RIDGWAY PLANNING COMMISSION

REGULAR MEETING AGENDA

Tuesday, November 30, 2021

To: Town of Ridgway Planning Commission
Cc: Preston Neill, *Ridgway Town Manager*
From: TJ Dlubac, AICP, *Community Planning Strategies, Contracted Town Planner*
Date: October 21, 2021
Subject: McIsaac Subdivision Planned Unit Development Preliminary Plan and Plat for October 26th PC Meeting

5 THRUST BLOCK SIZING
C6.1 N.T.S.

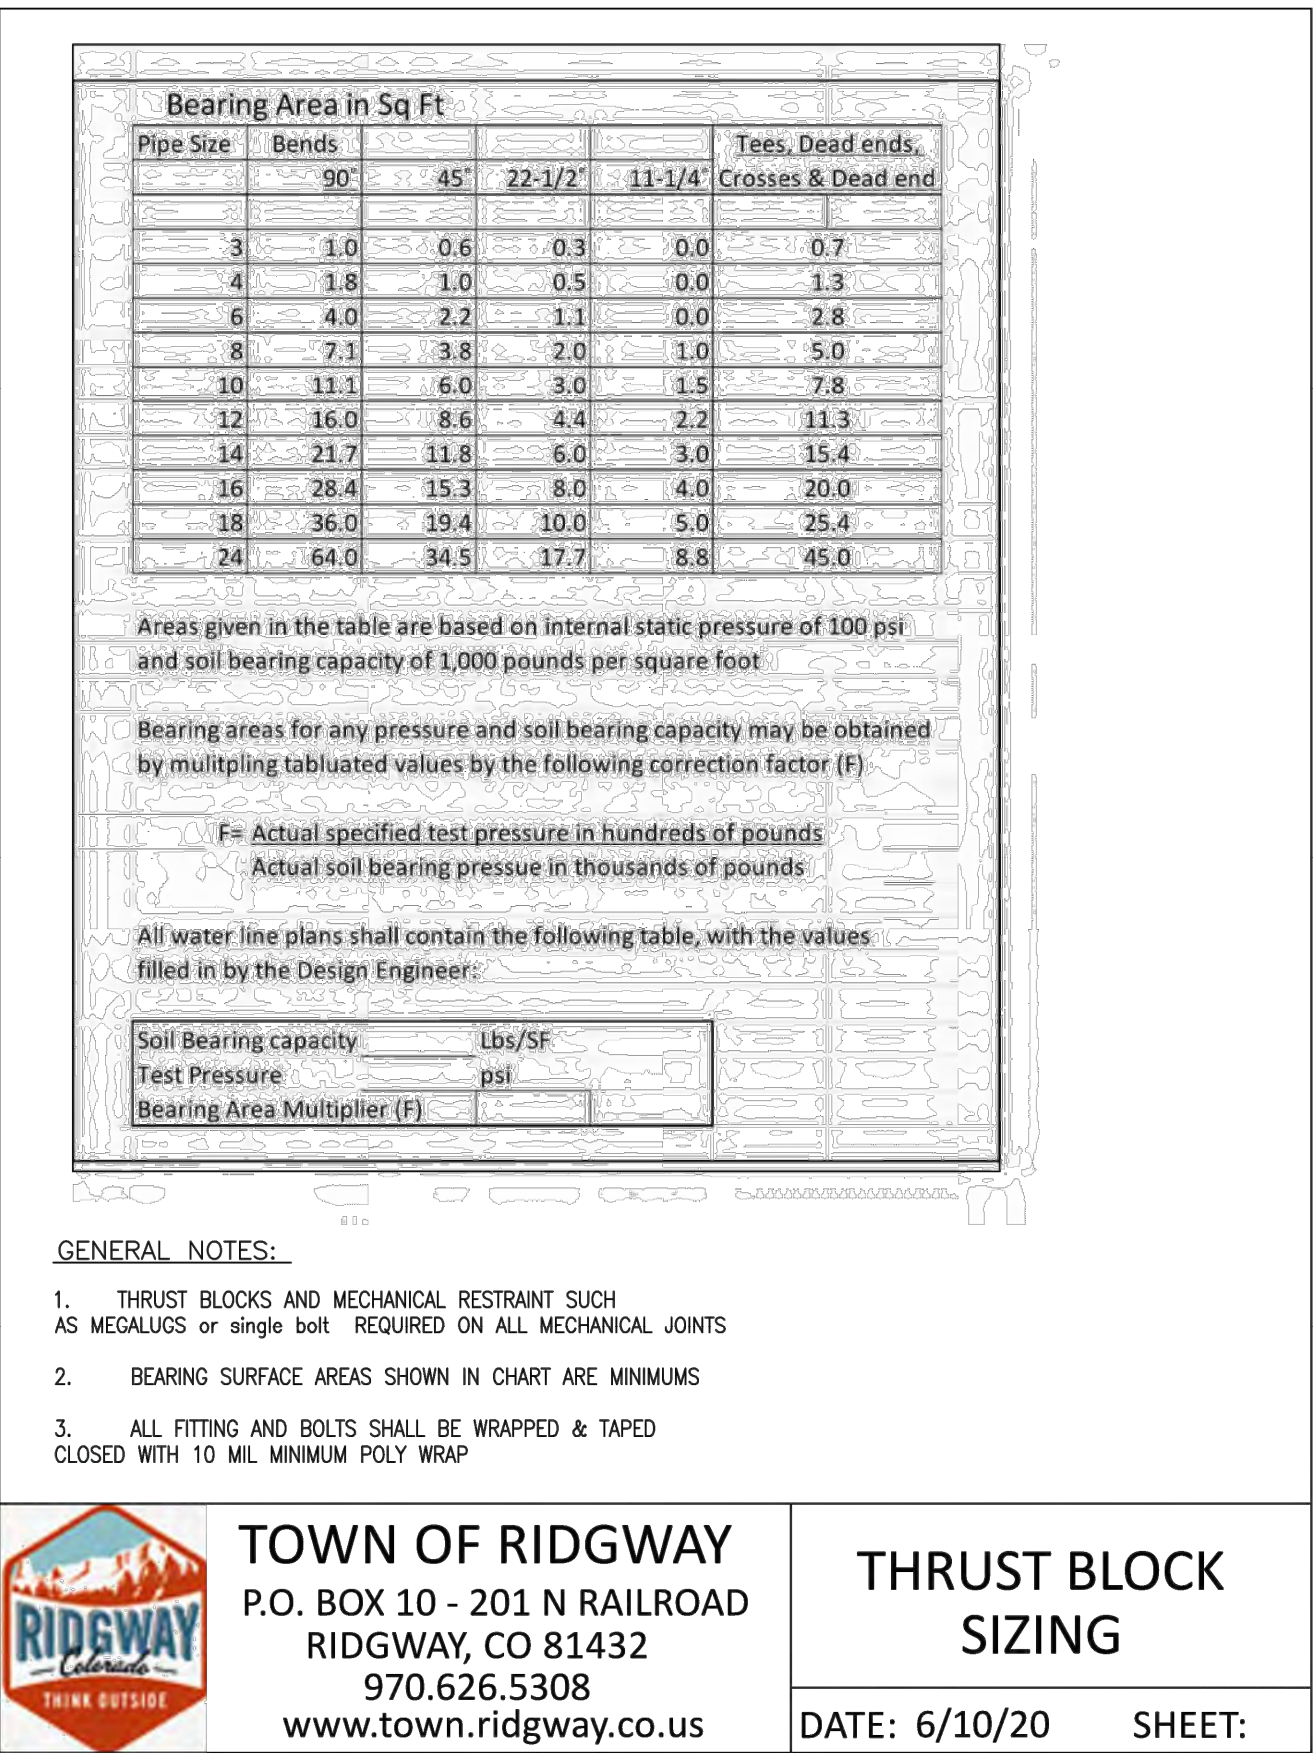
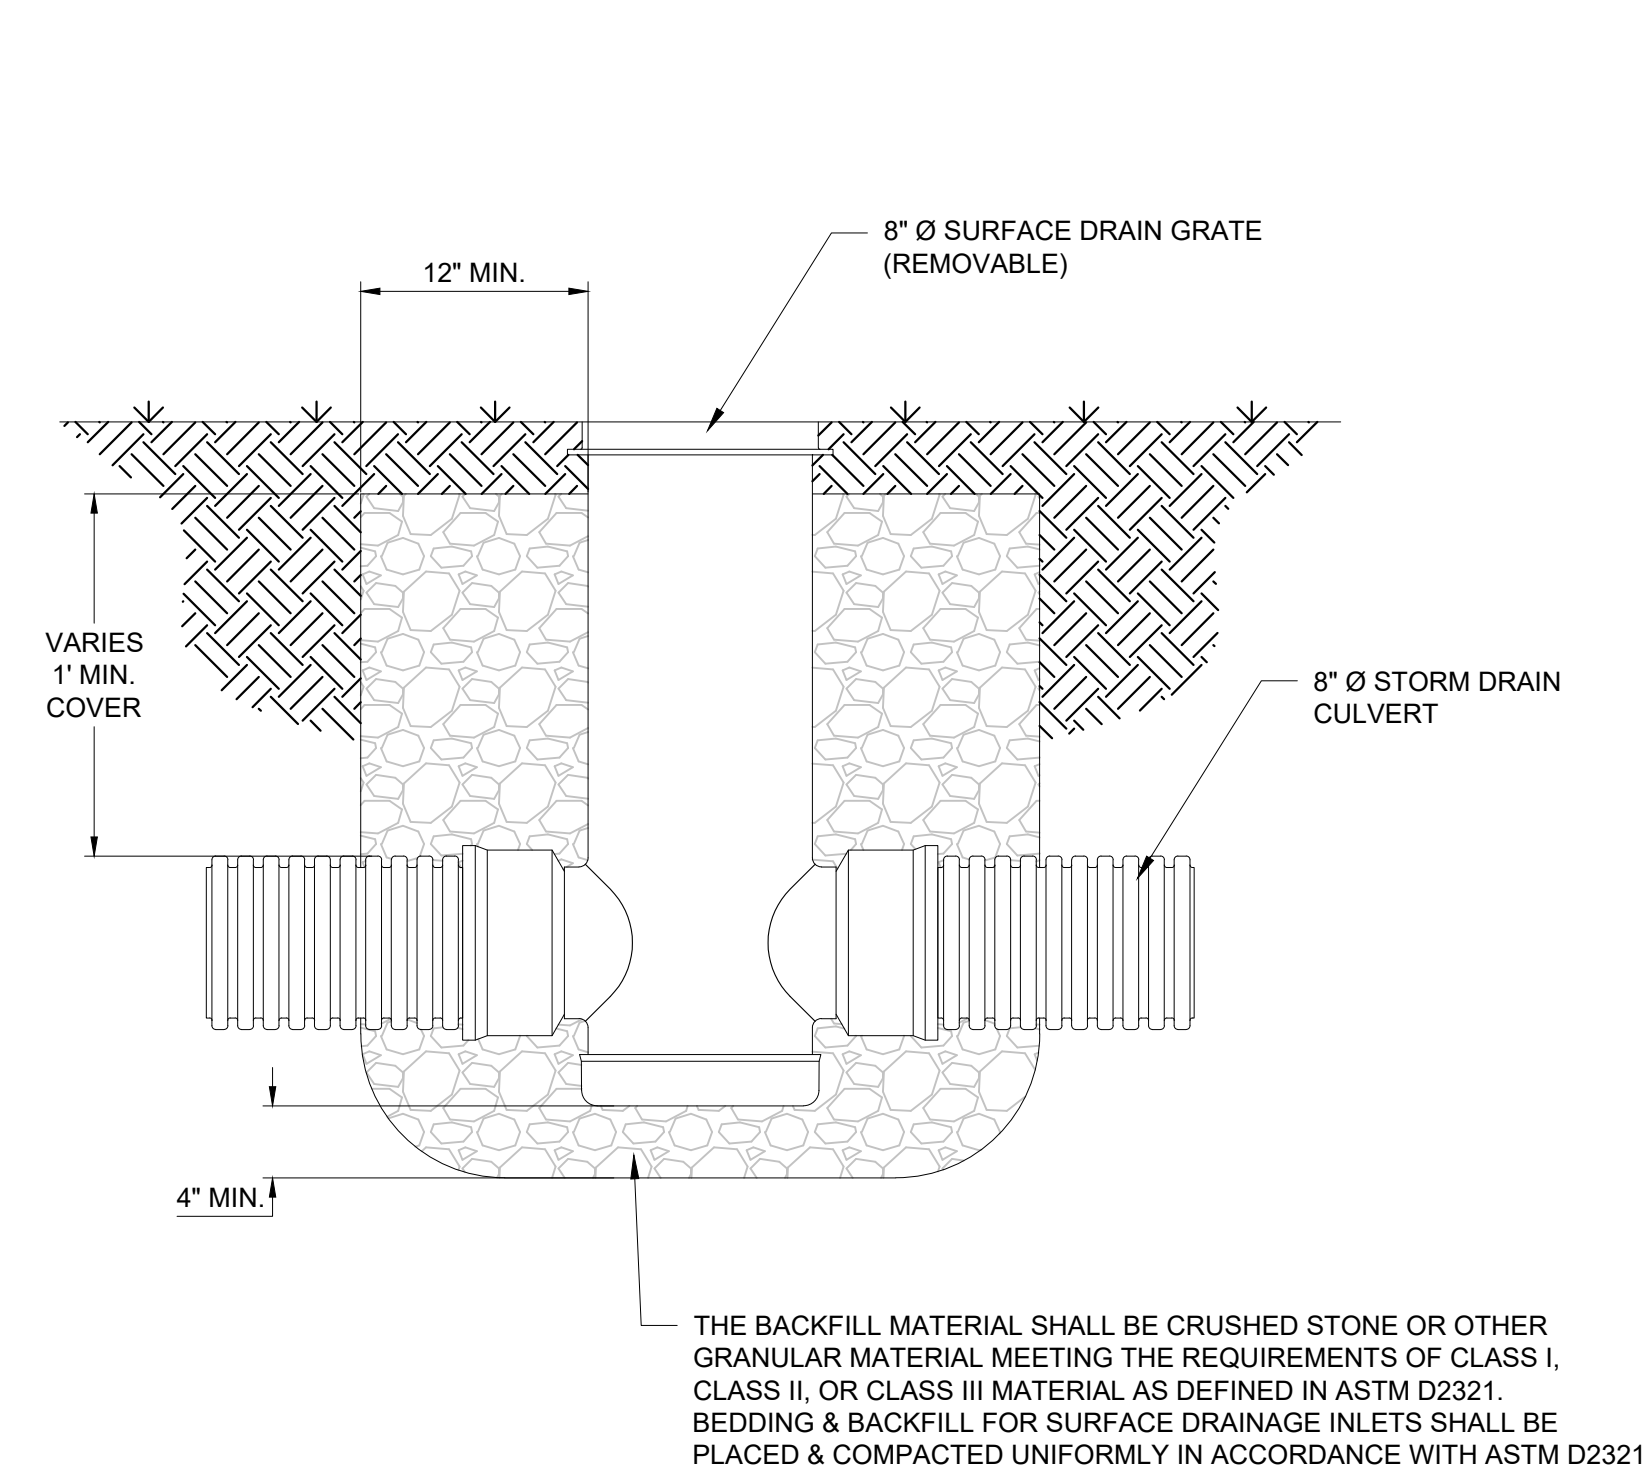
C6.1	Details	Curb Ramp Type3	Where is this proposed for use?	The plans should call out which curb ramp type from the M standard is needed in each locaton. Spot elevations should be provided to demonstrate maximum slopes won't be exceeded.	Please see sheet C2.0 for curb ramp type.	
C6.1	Details	Sidewalk Detail	The cross slope of the sidewalk can not exceed 2%, rather than that being the minimum percent. We recommend that the sidewalk be designed at 1.8% cross slope to leave room for a little construction error	Not addressed	Language updated from minimum to maximum slope of 2%. Detail has been moved to sheet C6.0.	
C6.1	Details	Curb and Gutter	Did the sketch plan approval require the wider sidewalk referenced in the notes on this detail? If so, then the sidewalk should be 8' wide. If the PC did not address this, I believe the notes are not relevant and the walk can be 5' wide.	Walks shall be at least 5' wide.	All sidewalks are 5' wide.Called out and dimensioned on sheet C2.0.

C6.1	Details	Encasement	The town prohibits concrete encasements in most cases. Please detail this detail and reference the Town typical drawing.	Added town typical		
C6.1	Details	Cross pan	Where is this proposed for use?	Not addressed	Potential use would be alley crossing at Cora St. May not be within developer scope.	
C6.1	Details	Standard Pipe Trench	Please use the Town typical detail instead of this detail. If there are items in the Town detail you would like include, please let us know what they are and we will evaluate	Added town typical

C6.1	Details	Curb Ramp Type3	Where is this proposed for use?	The plans should call out which curb ramp type from the M standard is needed in each locaton. Spot elevations should be provided to demonstrate maximum slopes won't be exceeded.	Please see sheet C2.0 for curb ramp type.	Have added details and reference to CDOT stds. If there is 6' or more from sidewalk to the back of curb, there should be no need to depress the sidewalk. Where there is a need to depress, that should be labelled with stationing, coordinates and spot elevations. Those are also needed around the ADA ramps. The typical 1/C6.0 says driveway widths are on the plans. I did not find those. I also did not find valley pan widths on the plans

C6.1	Details	Surface Drain				The bedding material is called out as Class I, II, or III ASTM 2321. I believe Class II is a single graded material. If that is used what keeps out the fines from above. Why not use a low permeability pipe bedding material per town standards. What is the material intended for the vertical tube and cap?						
C6.2		Water Meter Pit	Please use the Town typical detail instead of this detail. If there are items in the Town detail you would like include, please let us know what they are and we will evaluate	Added town typical. Given that they will have concrete walk and a landscape space, the town would prefer a curb stop and box instead of the ball valve in the meter can. That will be an update on the town standards later this year.		Please add a note to use the curb stop per the existing service detail rather than the ball valve						
C6.2	Details	Water Service Connection	The detail you have for the curb box is not covered in the Town standard. If the curb box is slip and the bonnet over the curb stop is placed so the pipe is in the middle of the opening, the block under the stop is a good idea. Just add notes to require a slip box and centering the pipe	Their detail is gone. We like their idea of the block under the stop. We will add that to the typical when we update later in the year.		Please add to note to put the block under the curb stop

PRELIMINARY PLAT
LOTS 1-7, RIDGSIX TOWNHOMES,
TOWN OF RIDGWAY,
SECTION 21, T44N, R10W, N.M.P.M.,
OURAY COUNTY, COLORADO.

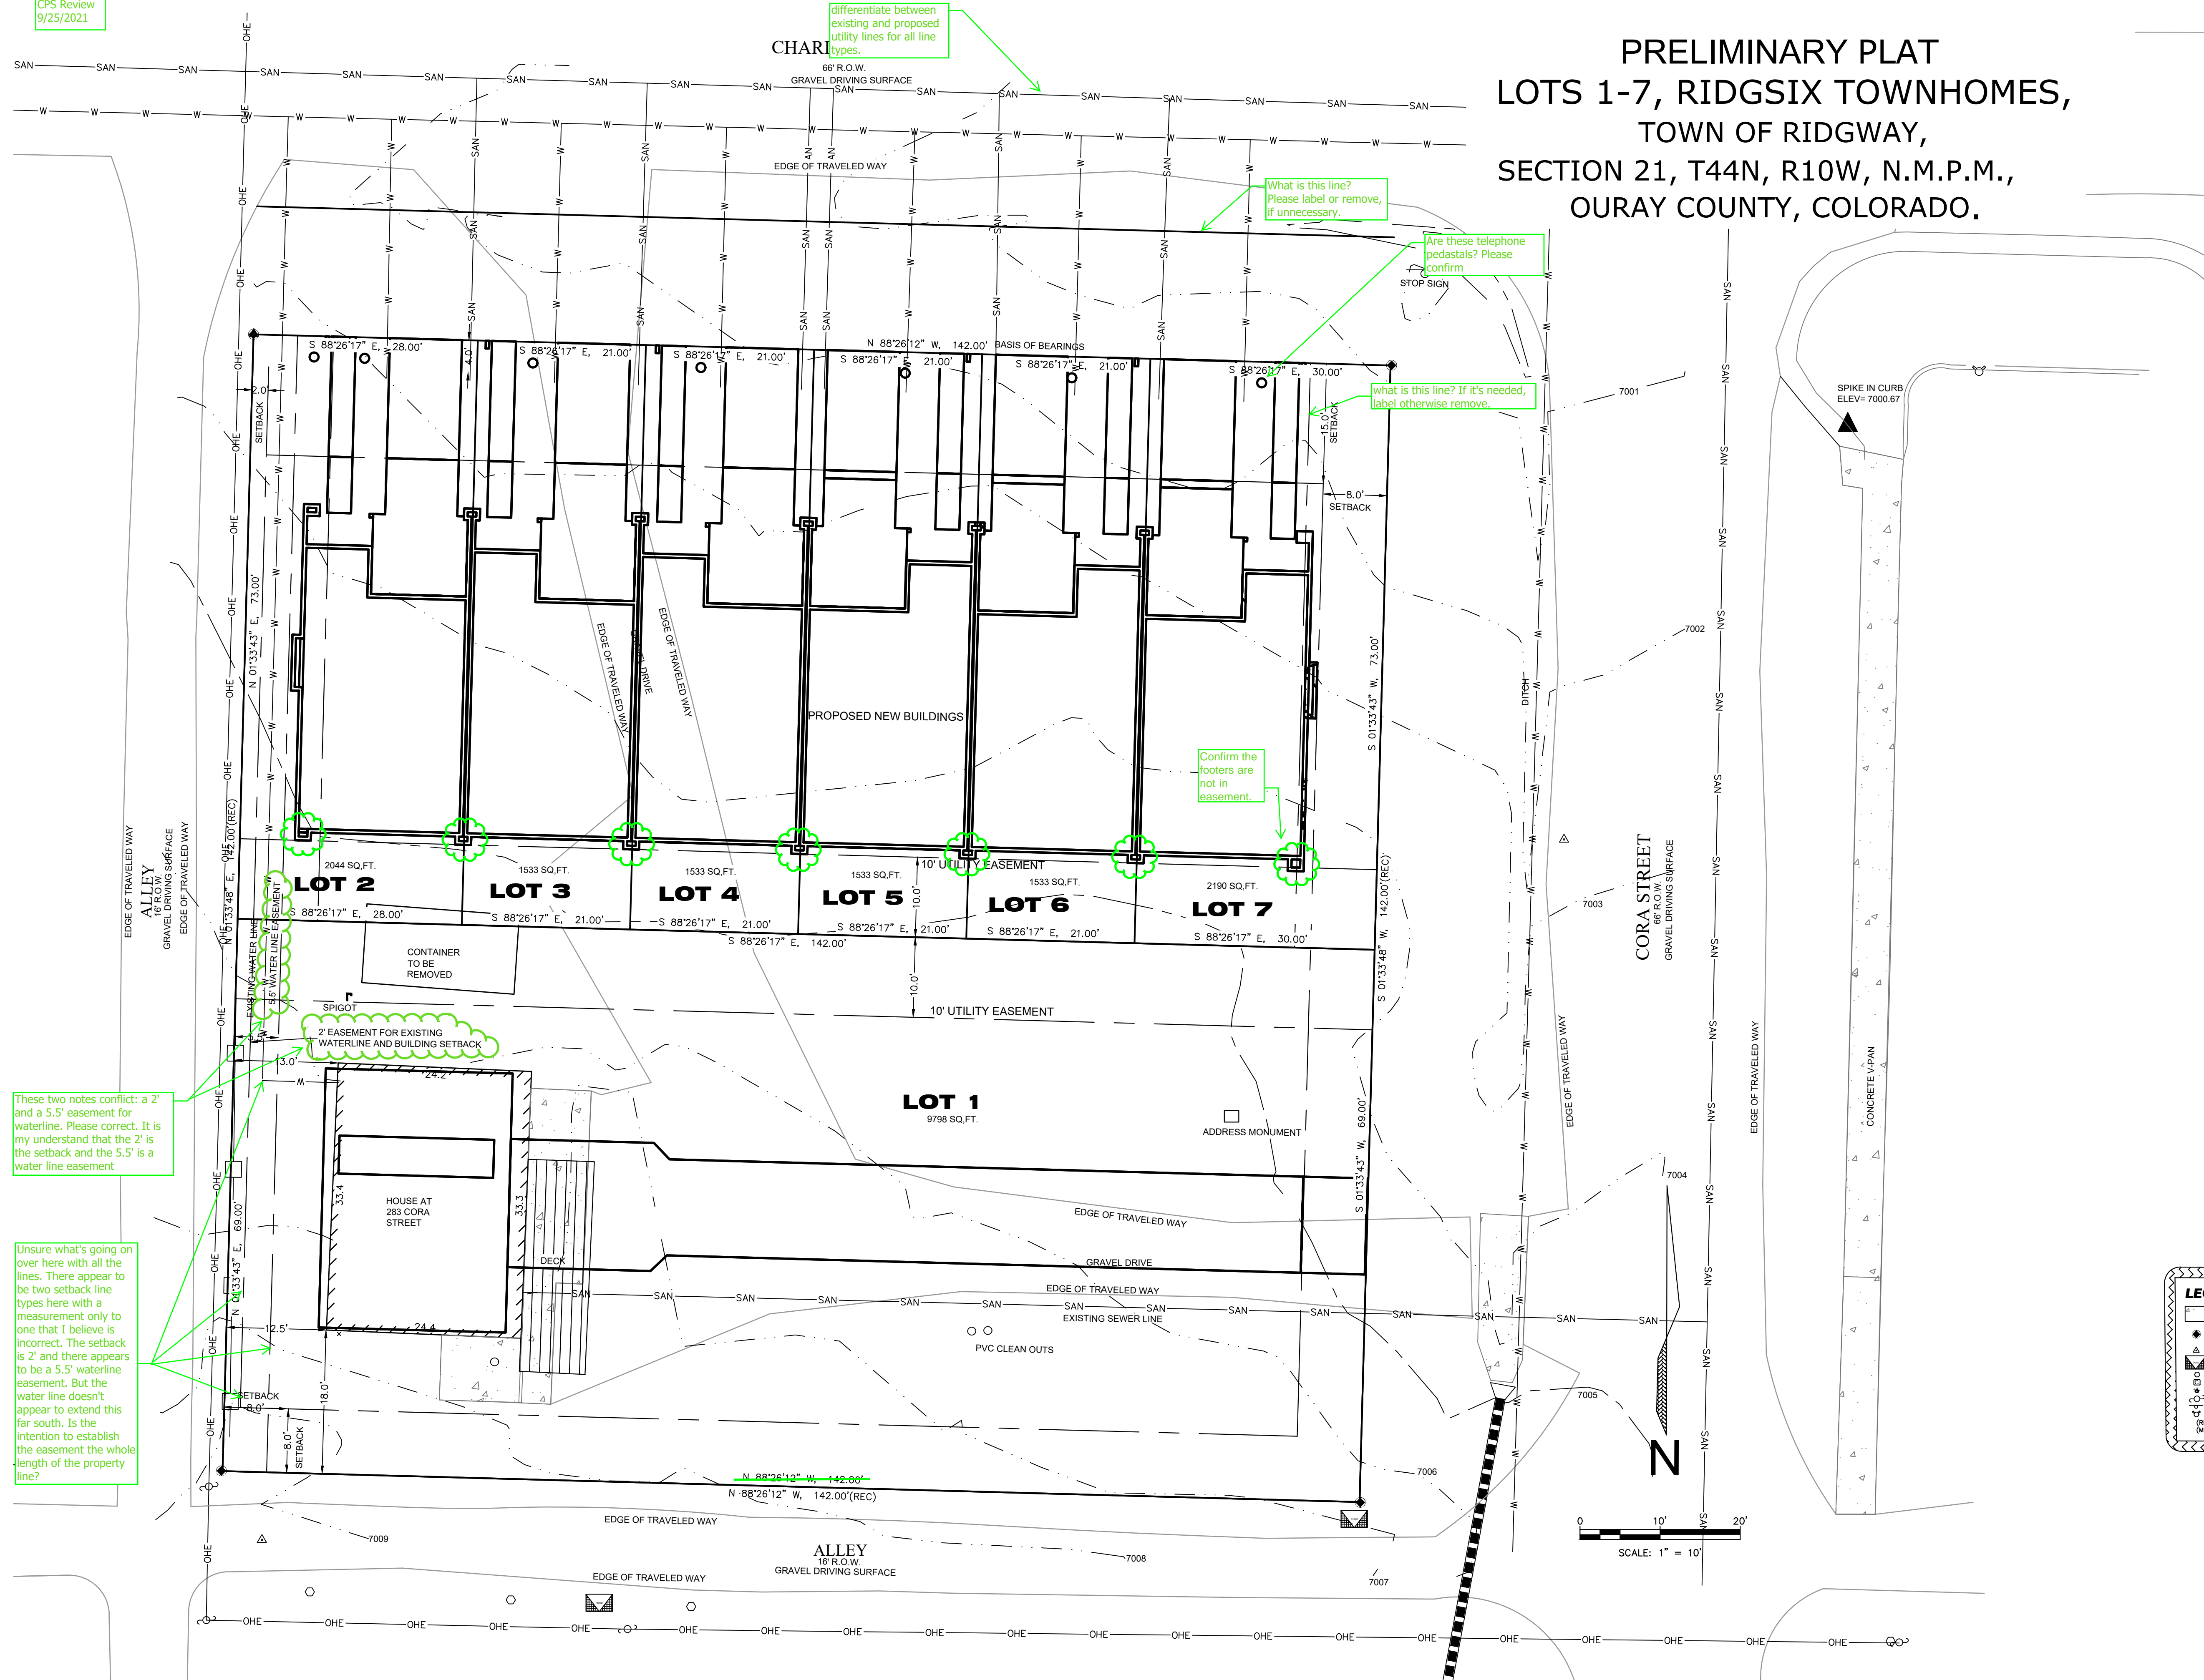
Standard	Required	Lot 2	Lot 3	Lot 4	Lot 5	Lot 6	Lot 7
Width	70'	28'	21'	21'	21'	21'	30
Size	10,000	2,044sf	1,533sf	1,533sf	1,533sf	1,533sf	2,190sf
Lot Coverage	50%	Not identified. Please add to Summary Table on Sheet 1 of plat. Include building footprints, driveways, and walkways in this calculation.

These two notes conflict: a 2' and a 5.5' easement for waterline. Please correct. It is my understanding that the 2' is the setback and the 5.5' is a water line easement
